SUBJECT: PLANS AND PROPOSAL ADDENDUMS

PROJECT: C 1597-4-12

COUNTY: COMANCHE

PROPOSAL ADDENDUMS

07/27/2023
 FM 1702
 CHAPPEL BRANCH
 CULVERT LAYOUT
 1597-04-012
 SCALE

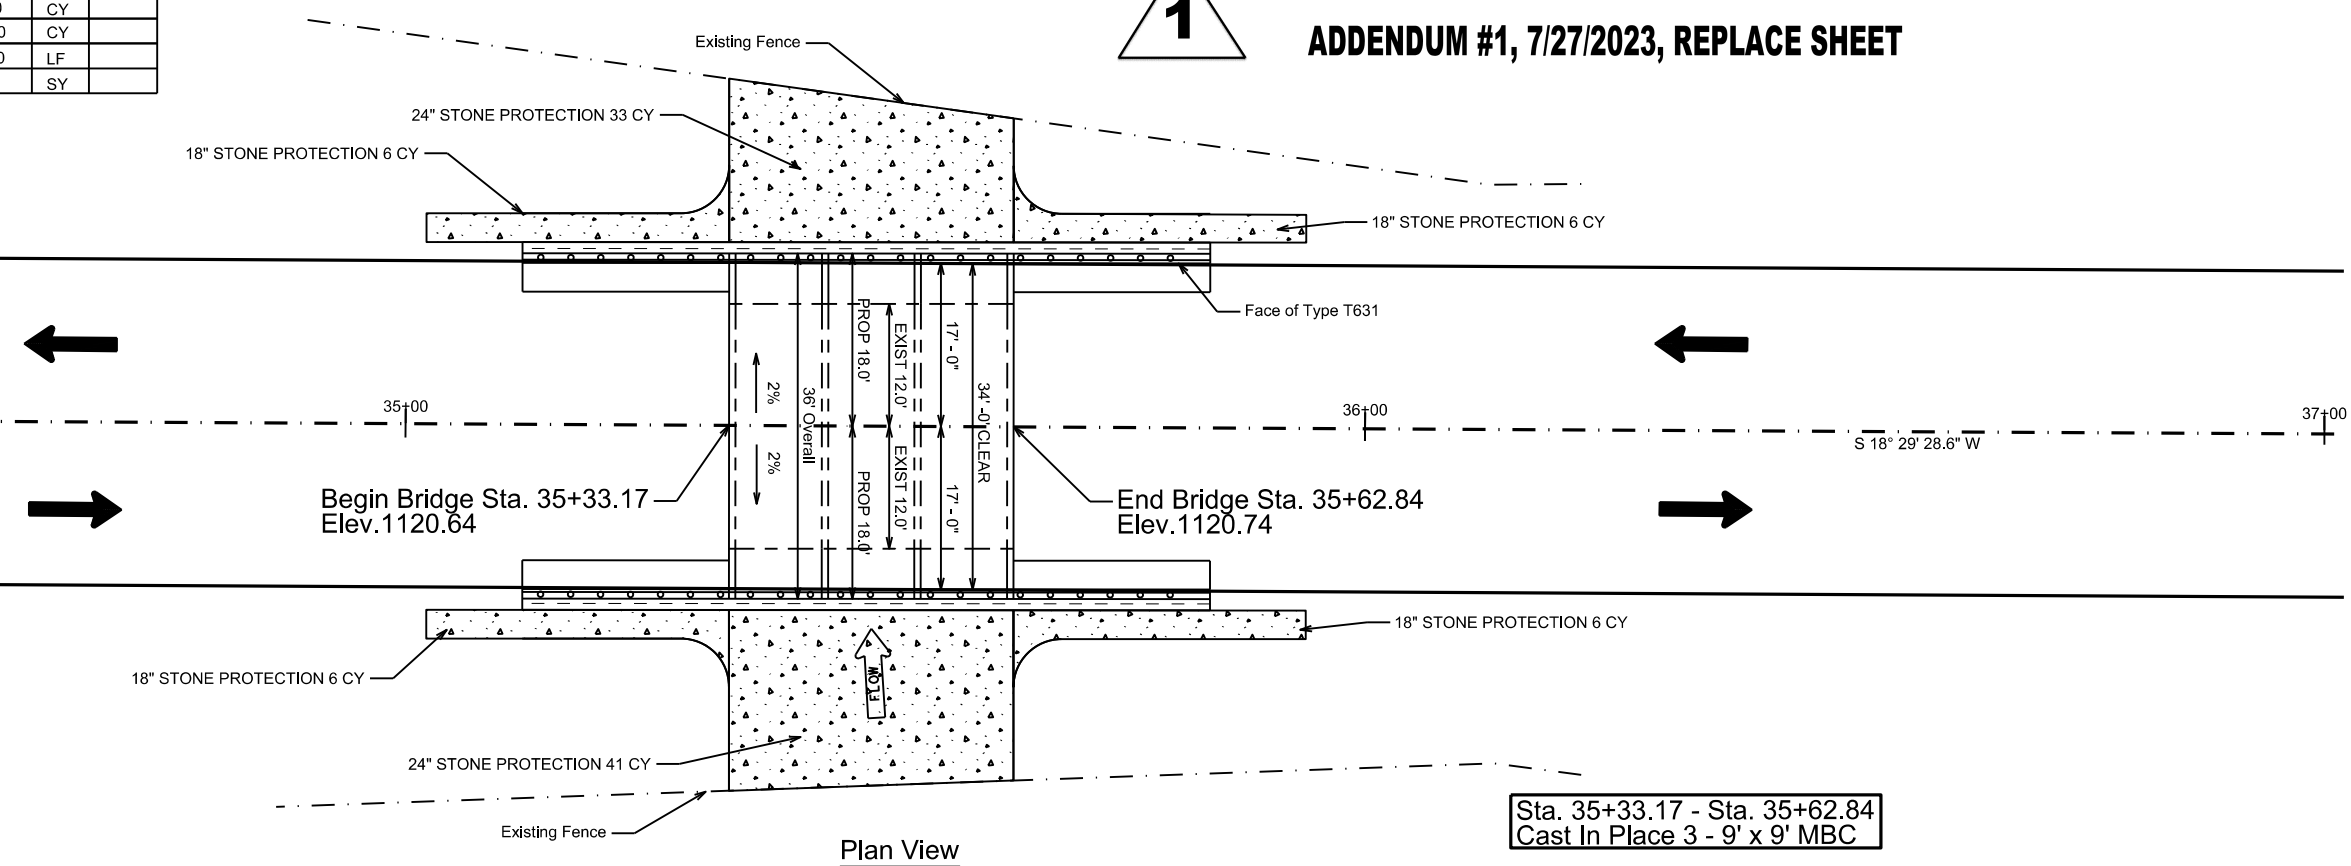
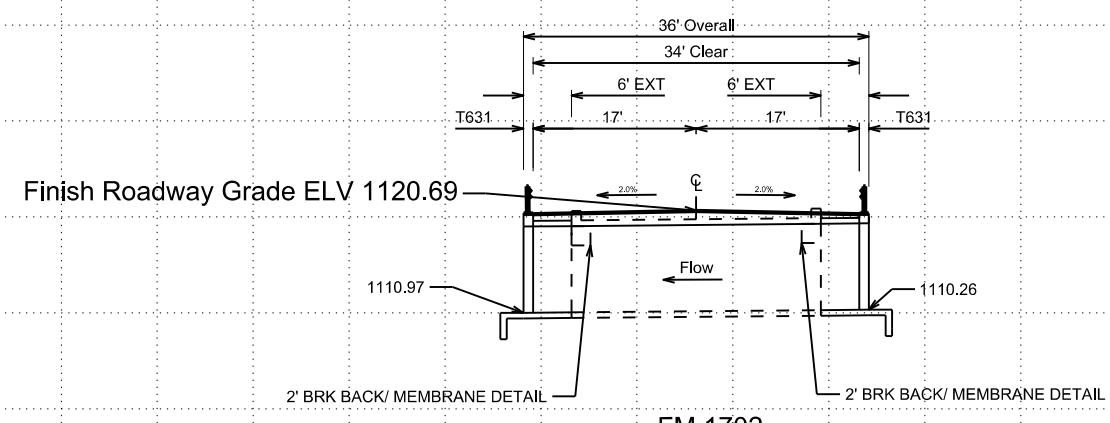
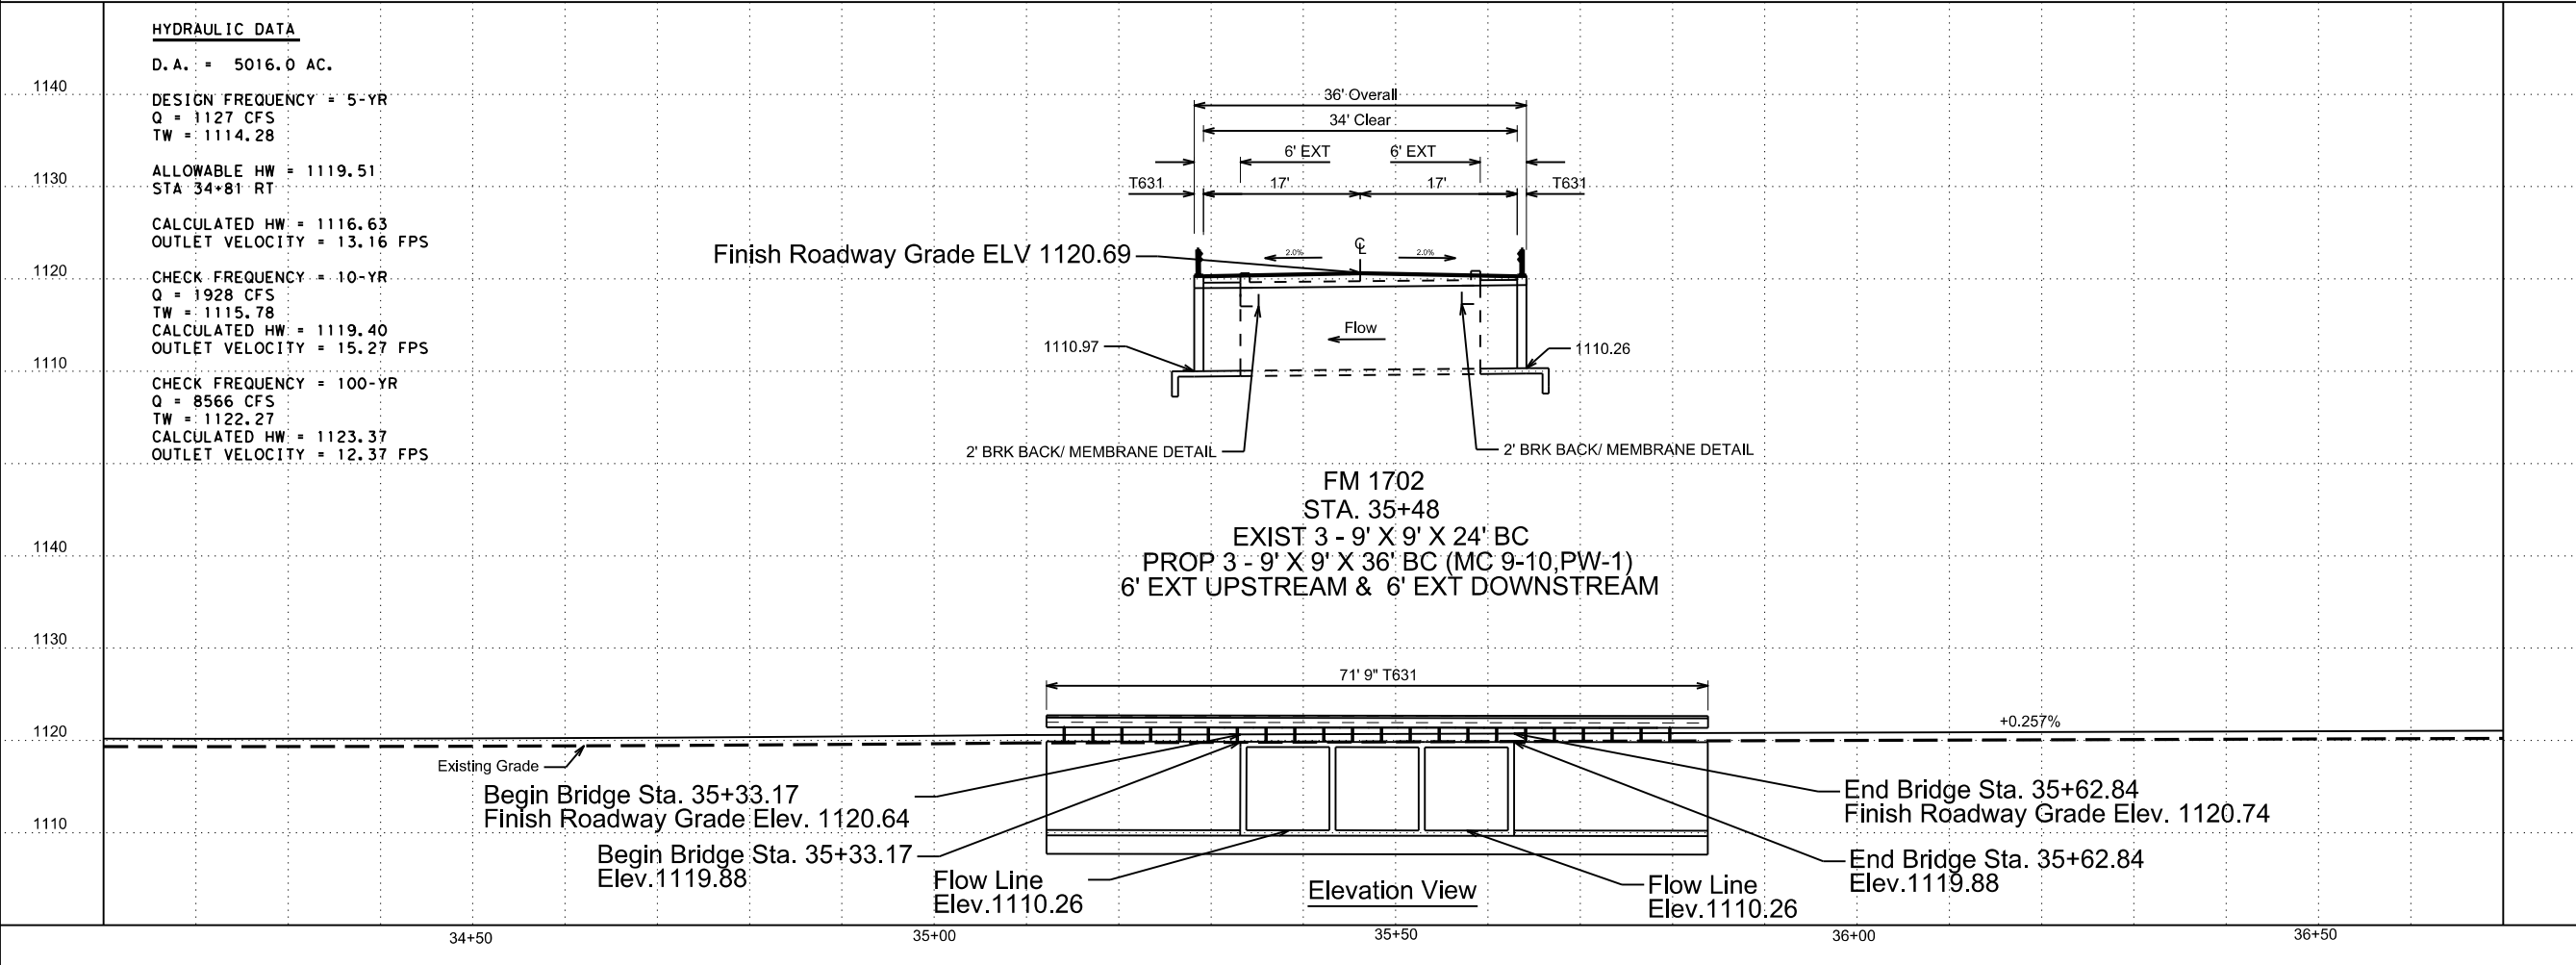
REVISED QUANTITIES FOR THE FOLLOWING BID ITEMS:
420-6051, 467-6143, 467-6217

REPLACED SHEETS: 3C, 5, 5A-5B, 97, 110, 113

FM 1702
 STA. 35+48
 EXIST 3 - 9' X 9' X 24' BC
 PROP 3 - 9' X 9' X 36' BC (MC 9-10,PW-1)
 6' EXT UPSTREAM & 6' EXT DOWNSTREAM
